Rezoning Transportation Analysis

Petition Number: 2024-129

Date	Description
11-26-24	First Review (CM)
12-23-24	Second Review (CM)
07-24-25	Third Review (CM)
08-20-25	Fourth Review (CM)
10-23-25	Fifth Review (CM)

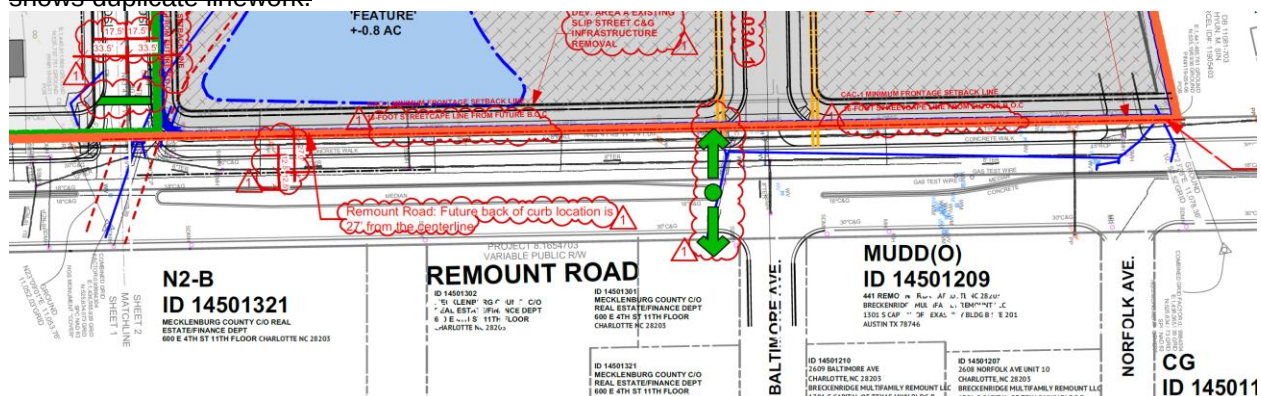
8. ~~Revise conditional Transportation note V.d to "the Petitioner shall dedicate and convey in fee simple all rights-of-way to the City before the site's first building certificate of occupancy is issued. CDOT requests rights-of-way set at 2' behind back of sidewalk where feasible."~~

~~Clarifying Comment 12.23.24: Replace note V.h with language above. Remove reference to phasing.~~

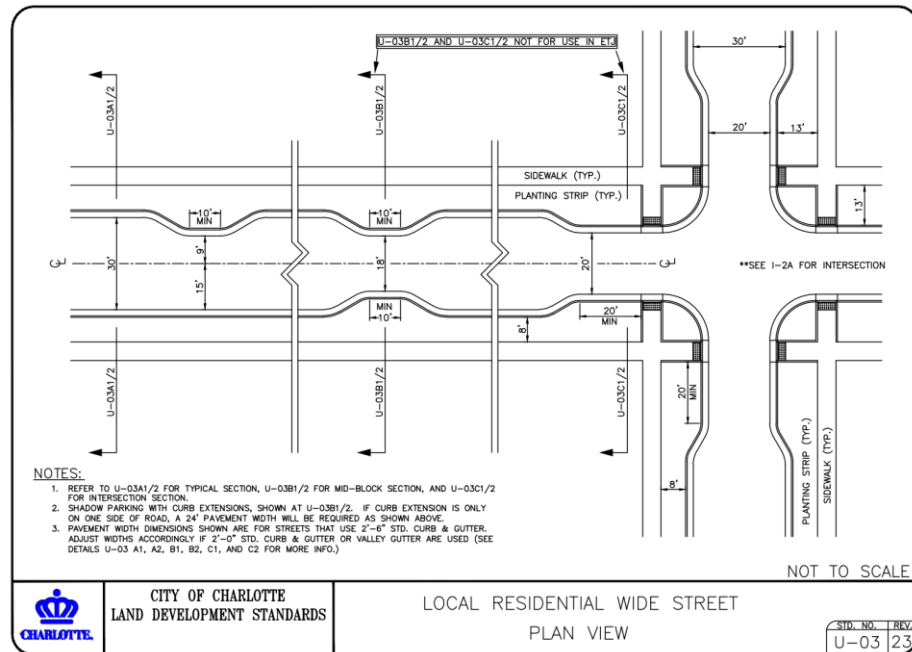
11. ~~New Comment 12.23.24: Revise site plan street sections of New Street A, B, Extension C, and D to CLDSM standard U-03.~~
